TO: El Paso County Planning Commission
Brian Risley, Chair

FROM: Kari Parsons, Senior Planner
Jeff Rice, PE, Senior Engineer
Kevin Mastin, Interim Executive Director

RE: Project File #: PUDSP-22-001
Project Name: Hillside at Lorson Ranch
Parcel Nos.: 55000-00-370, 55000-00-281, 55000-00-282, & 55000-00-283

EXECUTIVE SUMMARY

2) PEDESTRIAN RAMPS AT T-INTERSECTIONS

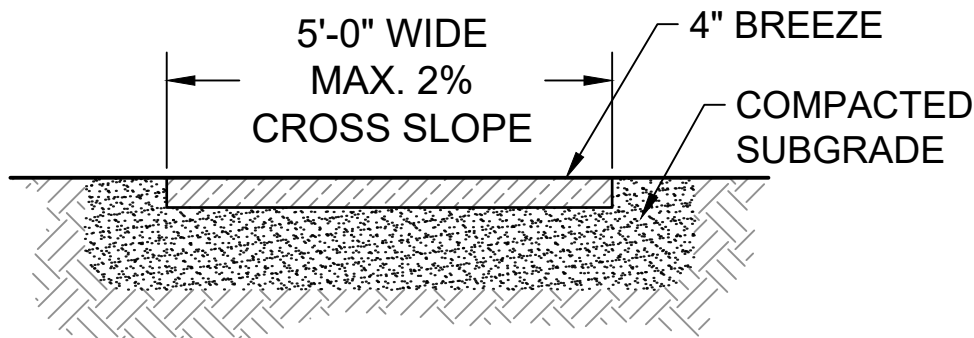
Requested Deviation: Allow only two pedestrian ramps to be constructed at the T-intersection of Hackberry Hill Street and Salt Spring Way.

Justification: The intersection is in close proximity of other intersections with all the required ramps constructed. Installation of an additional two ramps at this intersection is not feasible as the grading cannot meet ADA requirements along the ADA curb returns. The additional ramps may also be a safety concern as the removed crossing is in the middle of a large curve. The crossing at Salt Spring Way and Whiskey Hill Lane is approximately 225' feet away and provides a much safer intersection for pedestrian movements. The standard does not impose any particular hardship on the applicant. However, it will be more beneficial to pedestrian continuity and public safety.
